Note: This document is based on GRRF-74-18.

CLEPA/OICA comments to Japan proposal to regulate LKAS and PAS

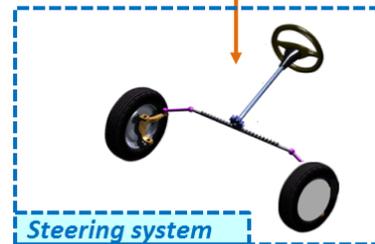
Yet OICA is ready to contribute to a debate at GRRF level for assessing how much UN R79 is appropriate with regard to the LKAS as “corrective steering” function and PAS as “Automatically commanded steering function” (see drawings below).

Changes with revision 1: the figures have been updated to reflect that LKAS are "corrective steering" and not "automatically commanded steering", which is prohibited above 10km/h by paragraph 5.1.6.1. LKAS corrects and is permanently monitored by the driver, who can override it if necessary.
